## STAFF REPORT

### PLANNING & ZONING COMMISSION

#### 1. CERTIFICATE OF APPROPRIATENESS

Applicant: Mathew Althouse  
Location: 26 W Olentangy Street  
Existing Zoning: Downtown Business District (DB)  
Request: To review a proposal to revert back to the previously approved architecture and site plan for a bar/tavern.

1  
A2.1 EXTERIOR ELEVATION - SOUTH  
1/4" = 1'-0"

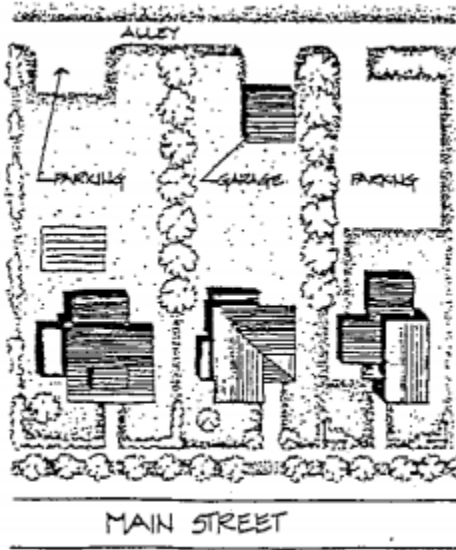
- The proposed project is generally in line with the architectural style recommended in the PAG.
  - The proposed building is in the general Midwestern rural aesthetic.
  - The existing building was added onto over time and although the building does not fit perfectly into the styles of the historic district, Staff feels that the improvement to the existing building using historic colors and materials. Furthermore, the building as it stands, has historic value as it is one of the older building in the downtown core.

- The proposed project is in line with site considerations of the PAG.
  - Access to rear yard parking lots and storage or garage buildings should be from alleys whenever possible.
    - The proposal has designed their parking lot in this fashion.
  - Commercial lots should be paved with asphalt, brick, concrete, or tar and chips as required in the Powell Zoning Code.
    - Renderings show an asphalt type of pavement.

RIBBON WINDOW

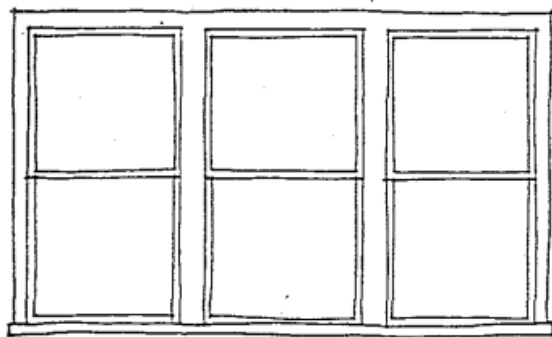
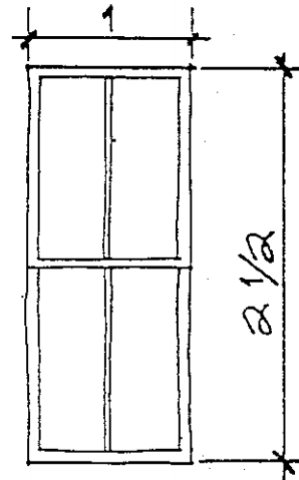
- The proposed project is somewhat in line with the PAG.
  - The front elevation of the proposal displays the Ribbon style, one of the three historically correct window styles with a 2-over-2 pattern. (Page 48)
    - Further examination by the Powell Architectural Advisor and HDAC is needed to determine whether the panels above the front windows are appropriate.
